VEGA

BARI, 6-6-84

MODIFICA VEGA (BLOCCAGGIO)

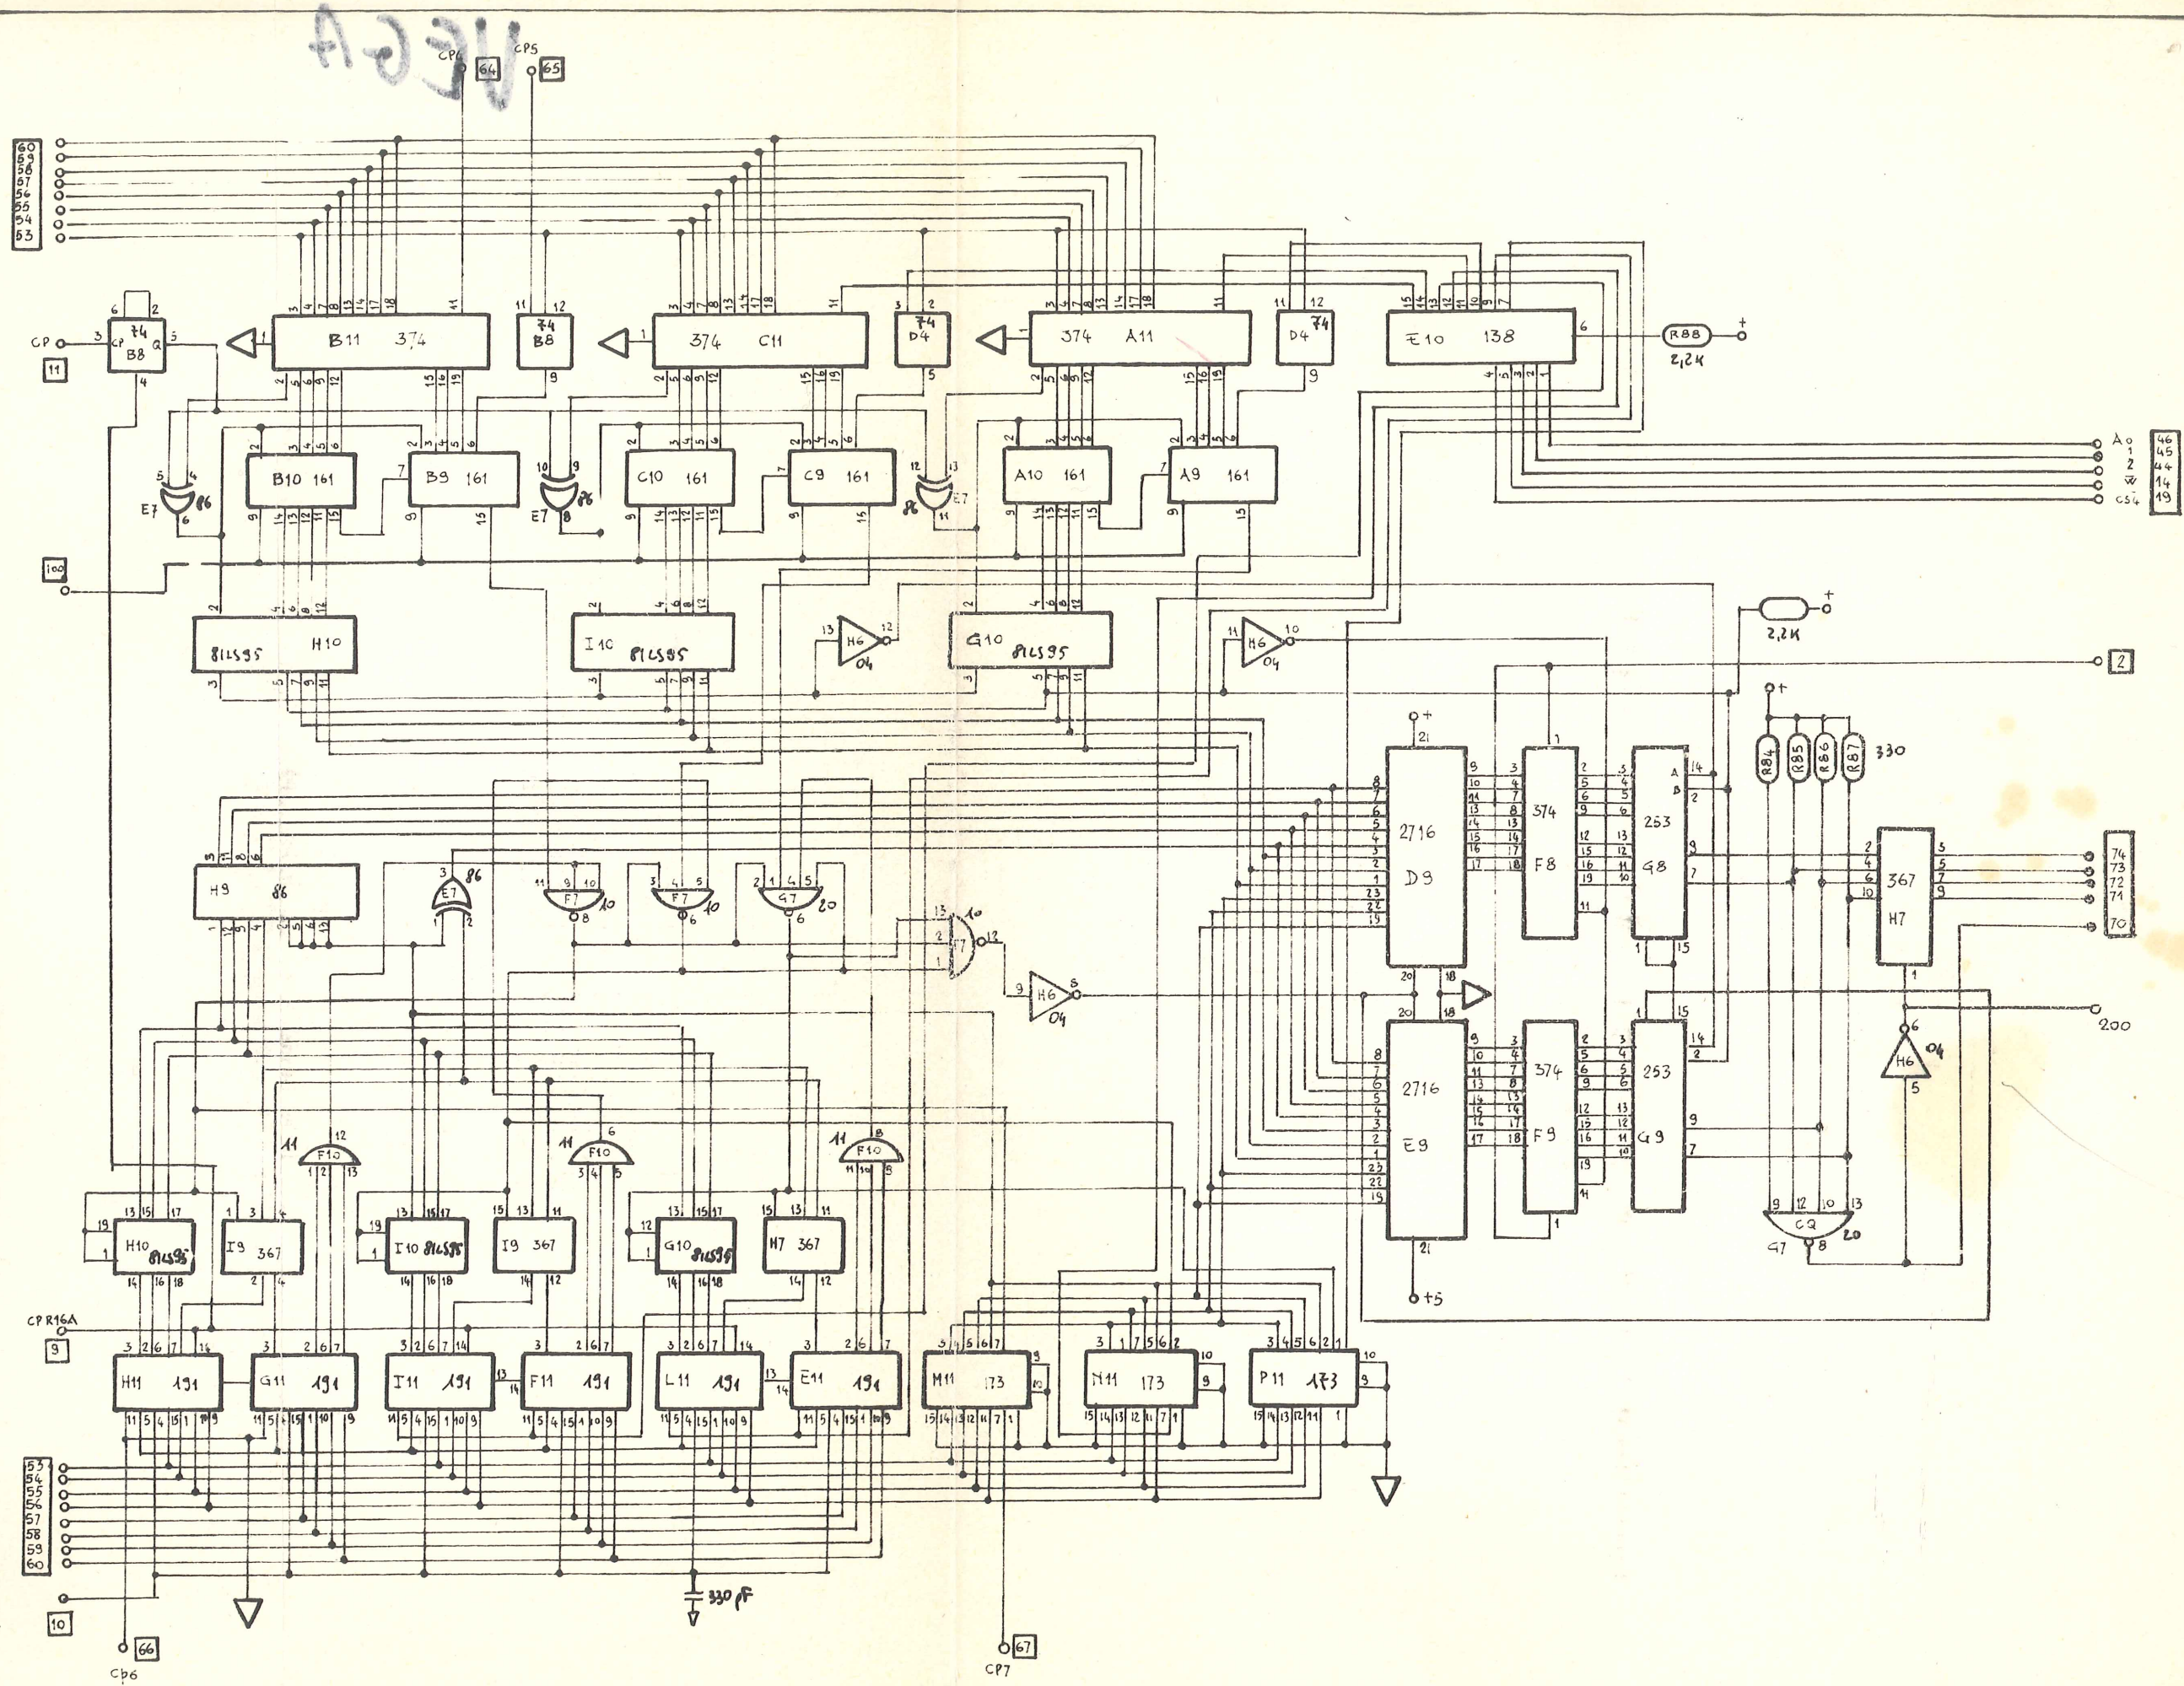
- COLLEGARE DUE DIODI IN4148 IN SERIE AL PIEDINO 16 DELLA R11 E TAGLIARE PIEDINO 9 DELLA R11
- AGGIUNGERE DUE CONDENSATORI, 0,001 μ F TRA P. 3 AL 8 E TRA P. 4 AL 8 DELLA R11
- AGGIUNGERE CONDENSATORE SULLA A6 TRA IL P. 13-14 DA 1 μ F.
- AGGIUNGERE RESISTENZA DA 330 Ω SULLA A1 TRA P. 11 A 5V
